## 253-255 Oxford Street, Bondi Junction (DA 386/2012)

### Report to Sydney East Joint Regional Planning Panel

Waverley Council Development Assessment Report	
Development Application No.	DA 386/2012
Address	253-255 Oxford Street, Bondi Junction
Lodgement Date	Original: 4 September 2012, Amended: 21 December 2012, 28 March 2013 and 19 April 2013
Proposal	Demolition of existing buildings and construction of a 19 storey mixed-use development containing 94 residential units, 6 retail premises and 3 levels of basement parking.
Zoning and relevant controls	<ul style="list-style-type: none"> <li>B4 – Mixed Use, Waverley Local Environmental Plan (Bondi Junction Centre) 2010</li> <li>Waverley Development Control Plan 2010</li> </ul>
Owner	Kelburn Holdings Pty Limited Nalela Pty Limited
Applicant	Legacy Property
Submissions	Original: 13 submissions Amended (28/3/13 & 19/4/13): 6 submissions
Issues	Materials & finishes, bulk, scale, setbacks, poor amenity for communal space, view loss, active frontage to Oxford St, land dedication, parking allocations, public art, potential land contamination

Figure 1: Extract of ground floor plan showing how glazing to retail should be re-aligned. Yellow denotes new internal area. Dotted line shows location of glazing on DA drawings.

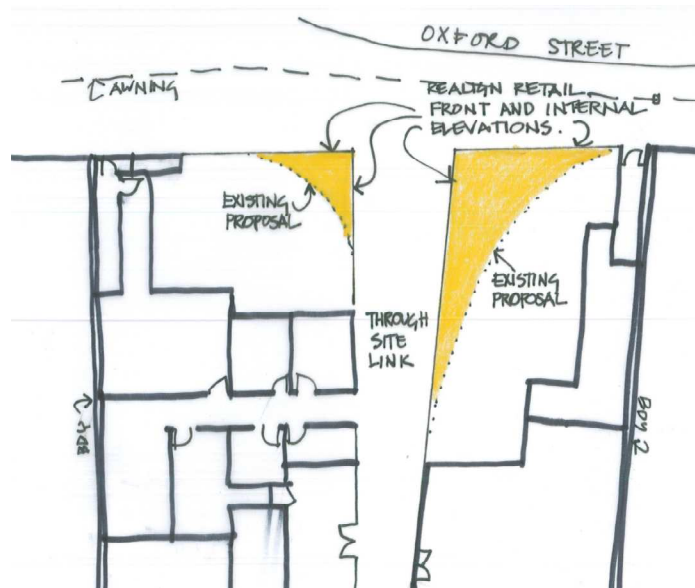
*The active frontages on the ground floor are supported. The design shows a curved wall at ground floor leading one to the through site link. The retail frontage should be revised to predominantly align with the street. See Figure 1 below.*

Accordingly, it is recommended that the entry to the through site link at Oxford Street be squared off, to provide a more solid retail frontage that predominantly aligns with the street. To ensure compliance with the FSR control is maintained, it is recommended the floor space be redistributed from elsewhere within the building (for example, the additional void area sought above the level 2 communal courtyard area provides for additional floor space that can be redistributed). This is recommended as a deferred commencement matter.
